**Addendum No. 2**  
**November 17, 2021**

Project: Corsica-Stickney H.S. Addition  
Corsica, South Dakota  
Architect's Project No.: 2910

Architect: Architecture Incorporated

3.55

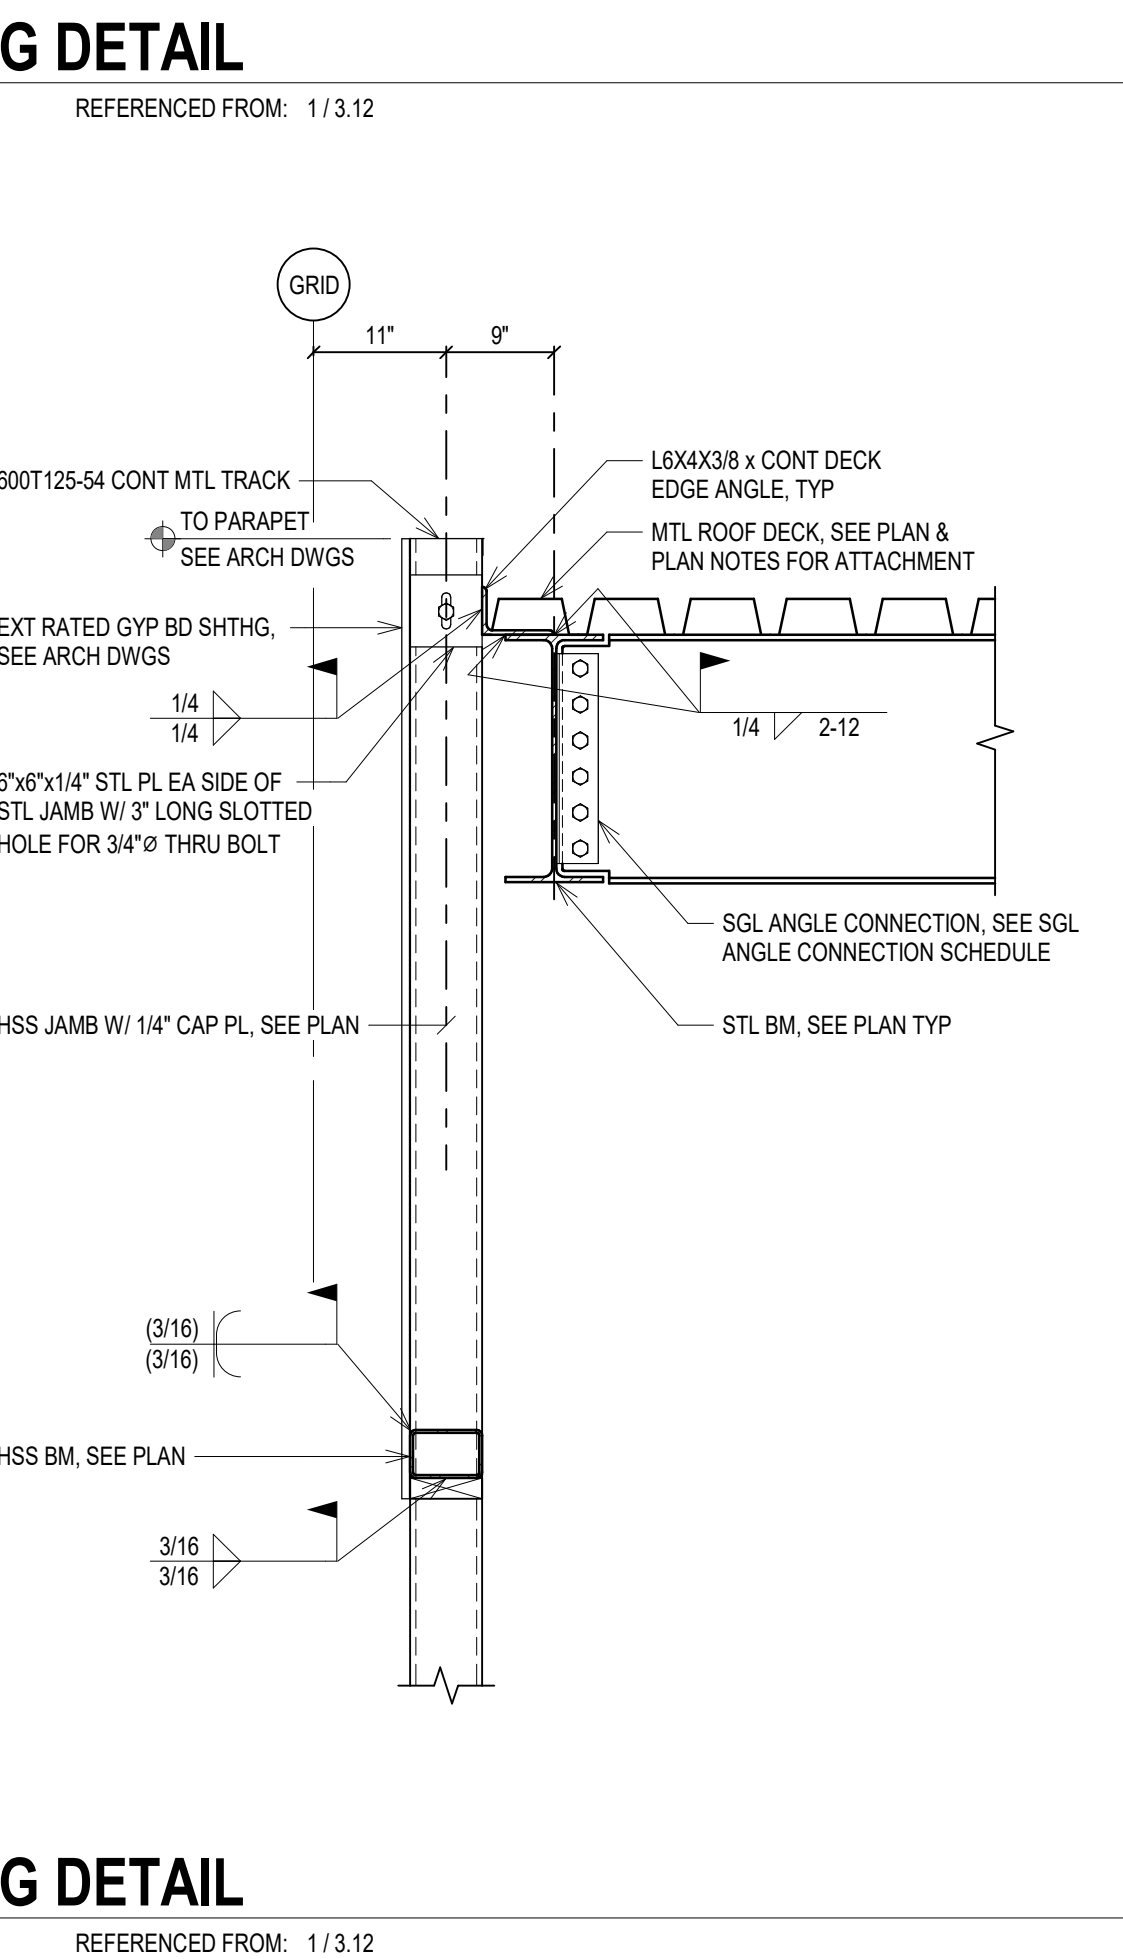
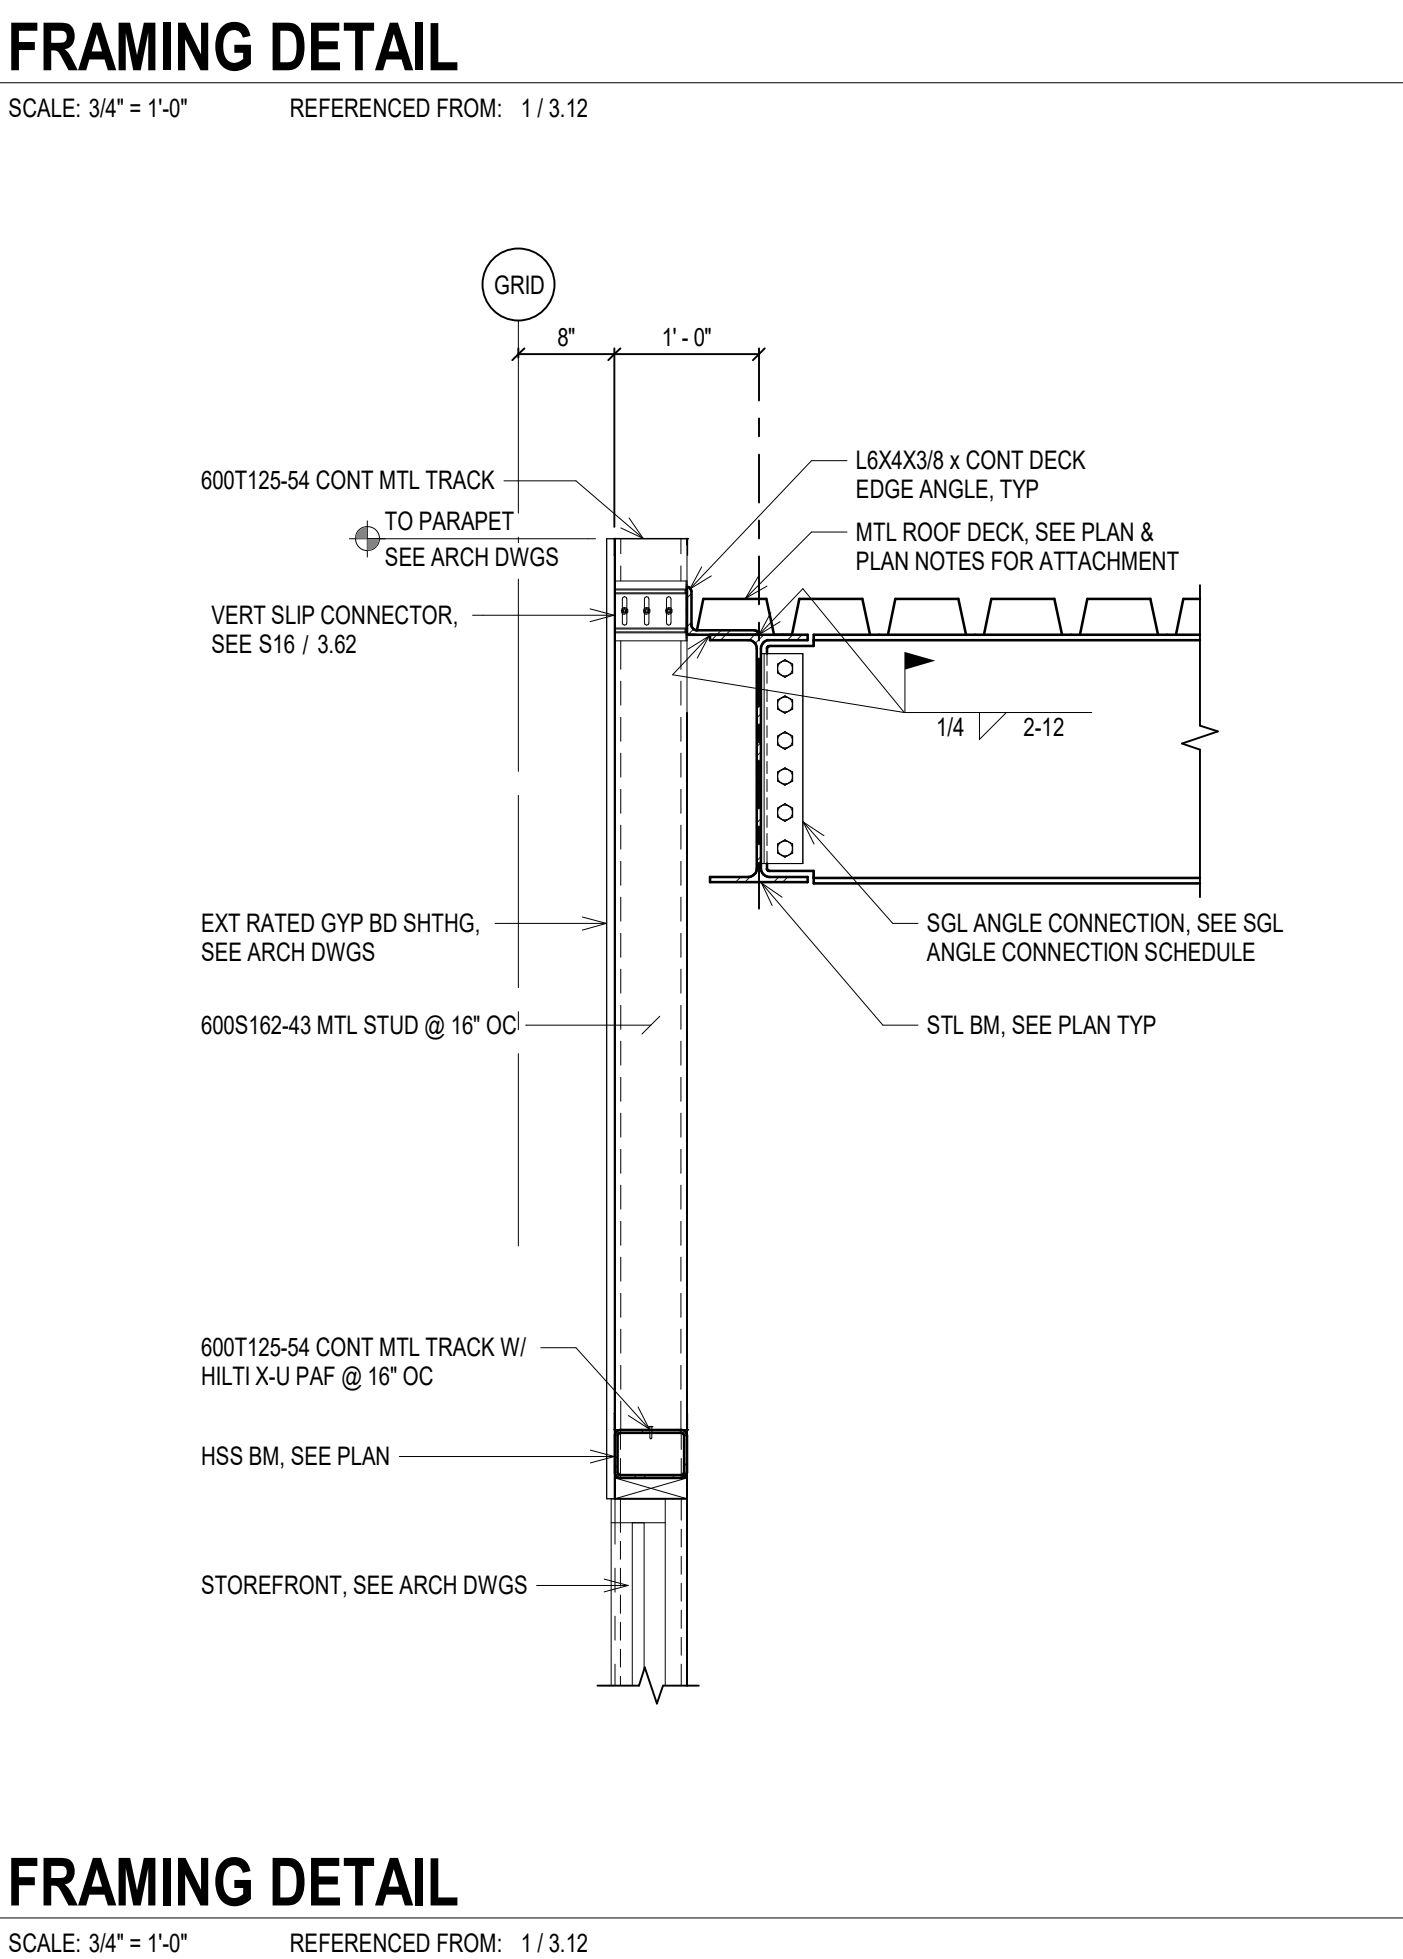
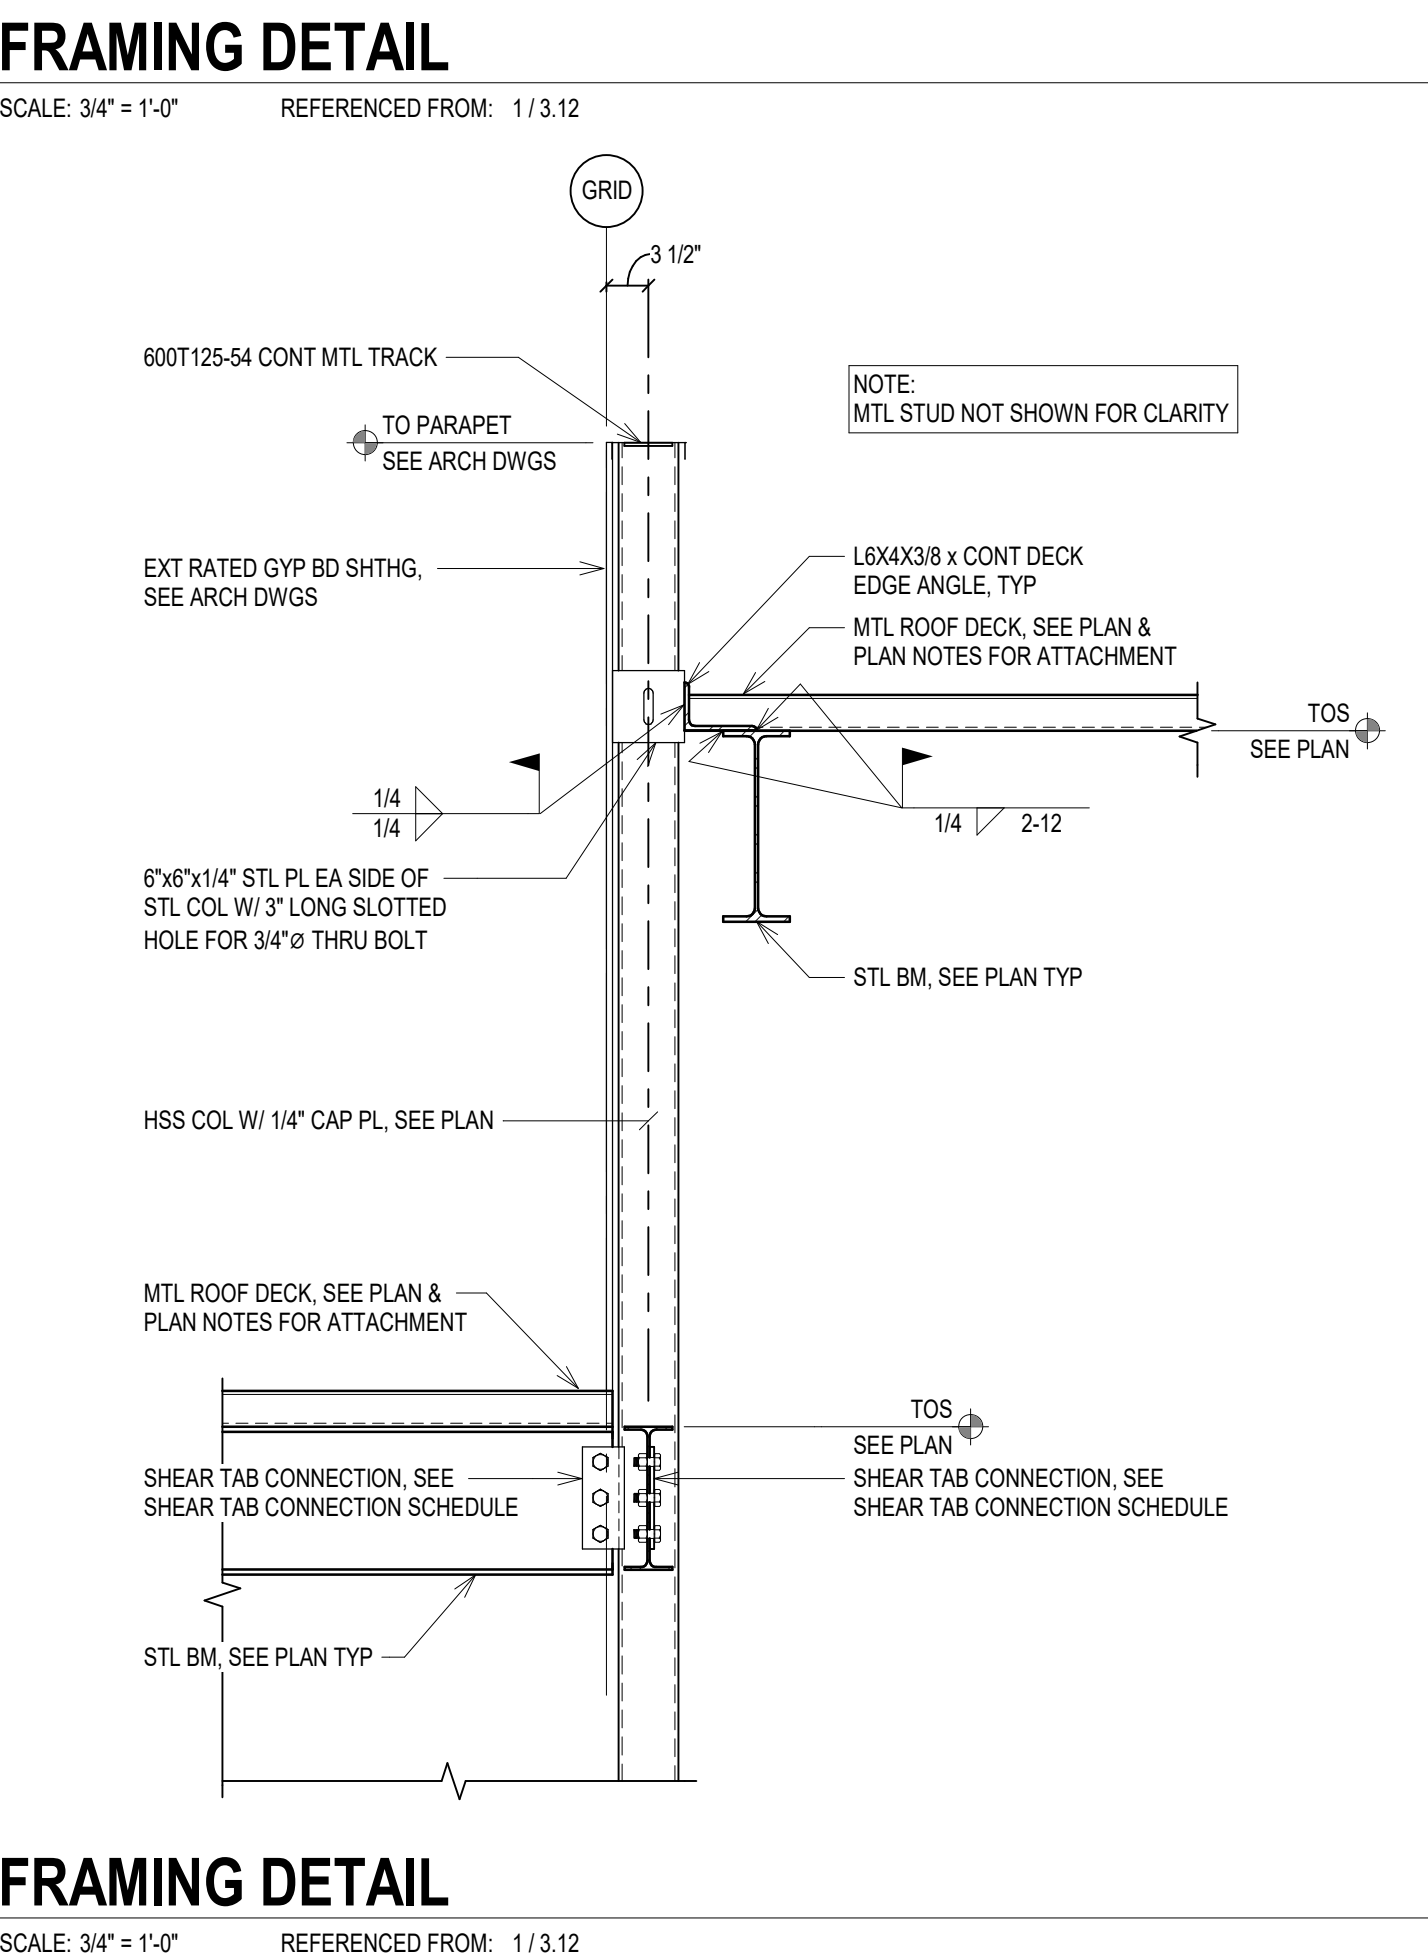
- a) See new sheets with changes to **MODIFY** the height of aluminum storefront.
    - i) SHEET 3.12 – ROOF FRAMING PLAN
    - ii) SHEET 3.55 – DETAILS
